WM Project Number: 14288

**Re: SCEGGS Redlands School (SDD 6454)
Response to Noise Issues raised by NSW Planning and Environment**

Figure 1 Aerial showing Noise Monitoring Locations

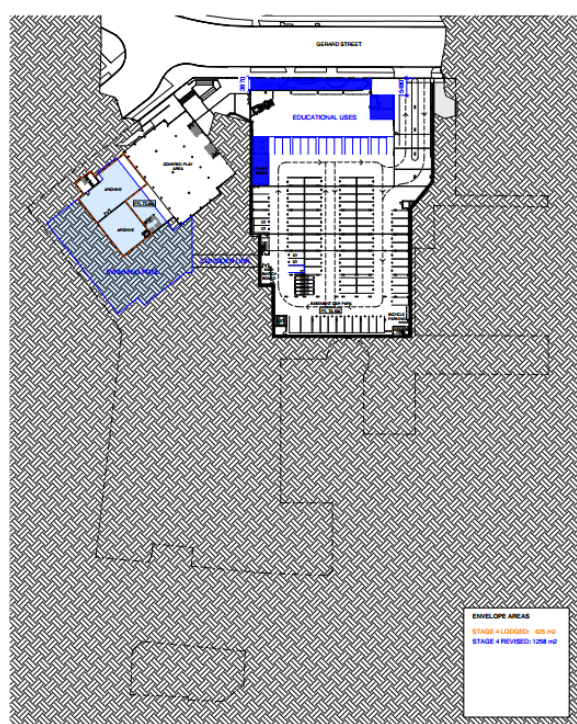
Item 7: The Department requires that further justification be provided regarding the proposed project specific noise criteria, noting that in absence of the proposed staged redevelopment, the school's operational intensity is not proposed to be increased.

Project Specific Noise Criteria have been established for surrounding receivers based on long term noise monitoring consistent with the requirements of the NSW Industrial Noise Policy (EPA).

The project application construction and operational noise report, number 14288-B dated May 2015 prepared by Wilkinson Murray, detailed the location of noise logging that was conducted between 20 – 27 November 2014. Two (2) locations surrounding the site were selected to cover the range of noise environments in the potentially affected areas being:

These locations are shown in Figure 1.

It is noted that the two locations are on the western and eastern side of the school which are adjacent to residences and away from the influence of traffic generated noise. As such the measured noise levels are lower than can be expected at receivers on Military Road or Gerrard Street.

Accordingly site specific noise criteria based on the measured levels at these locations will be lower and represent a more stringent approach to establishing noise criteria,

Based on site observations it was determined that monitoring location 1 noise levels should be used to established site specific noise criteria for Locations B– Military Rd and Location D – Gerrard Street. This is considered a conservative approach as Locations B and D are subject to higher contributions from traffic noise than Logger location 1.

In the case of Winnie Street residences the noise data from location 2 was used to establish site specific noise criteria. This location has lower ambient noise levels as it is surrounded by multi level residential buildings.

Therefore we consider that the project specific noise criteria that has been established is appropriate for the range of noise environments surrounding the school site.

SUMMARY OF MODIFICATIONS

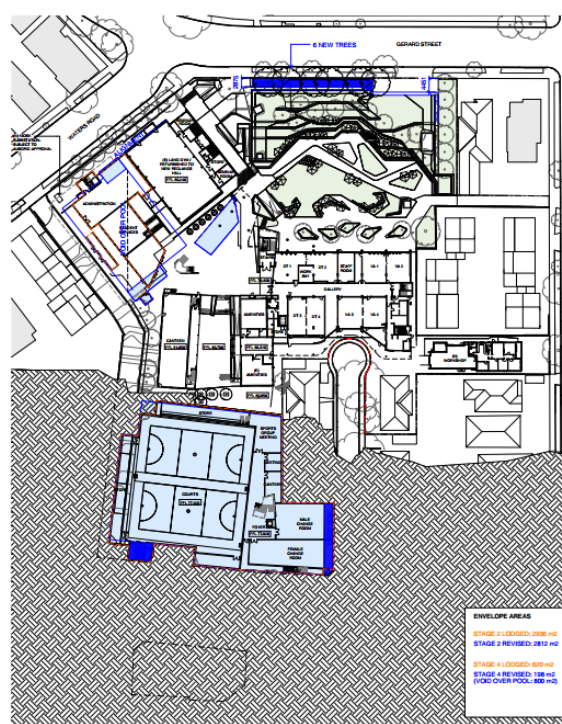
Item 8 The Construction and Operational Noise Report shall be revised to provide consideration and an assessment of amenity impacts on adjoining residential properties from the use of the rooftop swimming pool during the weekday/weekend and use of the proposed new internal link road from Waters Road to Military Road.

It is noted that the proposed swimming pool location has been revised from an outdoor roof level pool proposed in Stage 4 to an enclosed basement level location. The following figure shows this change.

As a result of the relocation of the proposed pool to the basement level any noise generated in this area will be contained within the buildings envelope. Any mechanical plant associated with the pool will be designed to meet the project specific noise criteria that has been established for this project.
